Addendum Landscape and Visual Impact Assessment

14th April 2025

Junction Rivers Wind Farm (SSD-30448824)

Addendum to Landscape Visual Impact Assessment (LVIA)

Figure 1. Aviation Obstacle Lighting Plan (Source: Aviation Projects, 2025)

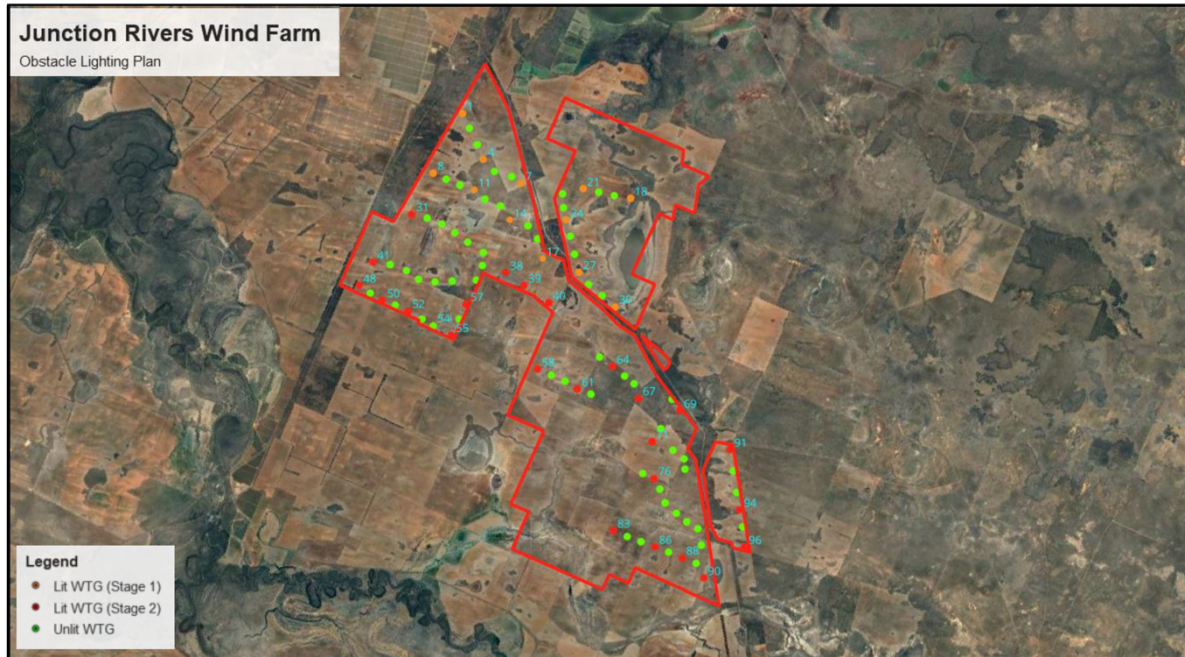
CASA considers the proposed wind farm will be a hazard to aviation safety and recommends that the wind farm is obstacle lit with steady medium-low intensity red obstacle lighting in accordance with the National Airports Safeguarding Framework Guideline D 'Managing the Risk of Wind Turbine Farms as Physical Obstacles to Air Navigation' National Airports Safeguarding Framework Principles and Guidelines (infrastructure.gov.au) and section 9.31 of Part 139 Aerodromes Manual of Standards Part 139 (Aerodromes) Manual of Standards 2019 (legislation.gov.au) (lower level lights on the turbine support columns are not essential).

International standards require 2,000 candela lighting intensity on the nacelle housing (also recommended in the NASF guideline) and 200 candelas at the mid-point of the turbine mast. CASA recommends that 200 candela as a minimum intensity lighting on the nacelle would suffice (due mainly to the lack of background lighting in the vicinity of the turbines). The obstacle lighting should be monitored to alert the wind farm operator of any outage and at

least some of the obstacle lights remain on during an outage. CASA is prepared to review a lighting plan that indicates which turbines are proposed to be lit.

In accordance with the recommendation of CASA, Aviation Projects have prepared an Aviation Obstacle Lighting Plan. The plan proposes a total of 36 WTGs (12 WTGs in Stage 1 and 24 WTGS in Stage 2) to be lit with 200 candela (cd) low intensity obstacle lighting (refer to **Figure 1**).
